PLANNING & DEVELOPMENT COMMITTEE

19 SEPTEMBER 2019

APPLICATION NO: 18/1090/10 (CHJ)
APPLICANT: Mr P Mortimer
DEVELOPMENT: Construction of 20no industrial starter and hybrid industrial/office units incorporating B1 (Business), B2 (General Industrial) and B8 (Storage & Distribution) class uses (Additional information received 15/07/2019)
LOCATION: LAND AT WELLINGTON STREET, ROBERTSTOWN, ABERDARE
DATE REGISTERED: 15/07/2019
ELECTORAL DIVISION: Aberdare West/Llwydcoed

Figure 4-10 of the FCA (extract below) illustrates the difference in flood depth during a 0.1% as a result of the proposed development.

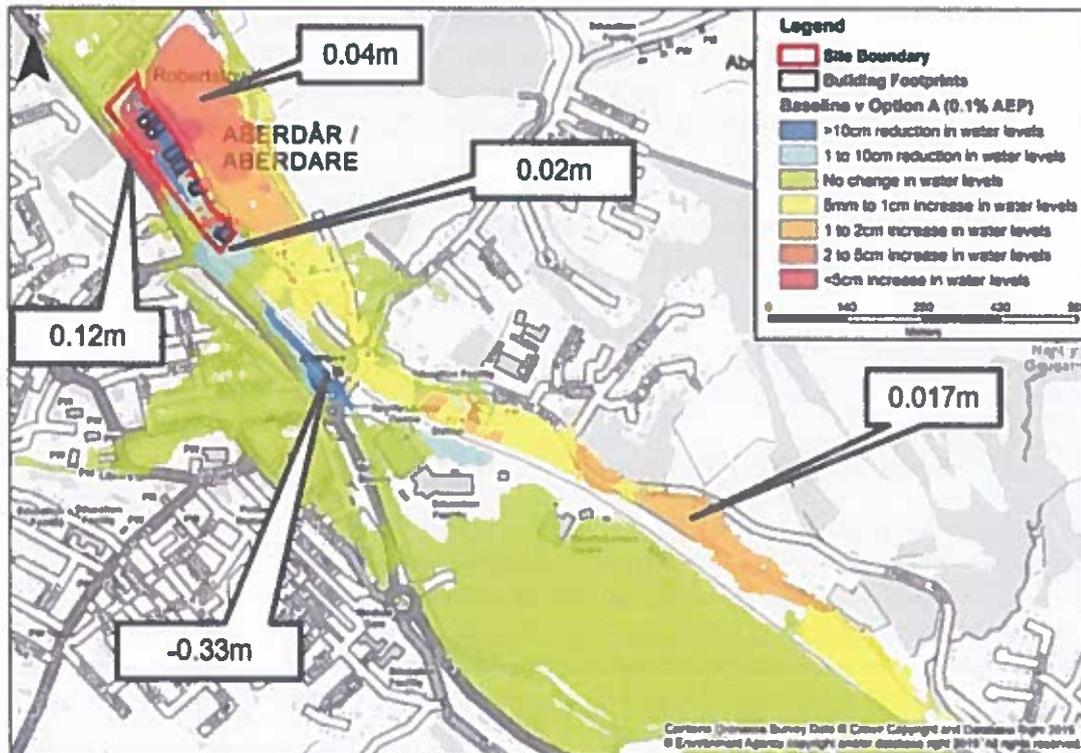
During the 1% (1 in 100 year) plus an allowance for climate change flood event there is an increase in flood depth of 40mm on the railway line to the west of the development. The flood depth on the A4059, which runs along the western boundary of the site is shown to increase by 80mm. These areas are already at risk of flooding during this event, with flood depths ranging from 300-900mm. We note there would be no change in flood hazard rating for these areas.

During the 0.1% (1 in 1000 year) flood event the impact on flood risk elsewhere is more widespread, with large areas to the east of the site experiencing increases in flood depth ranging from 9 – 50mm. These areas are already at risk of flooding during this event and we note there would be no change in flood hazard rating for these areas.

Our advice is that due to the increase in flood risk outside the development site, this development is not in line with section A1.12 of TAN15.
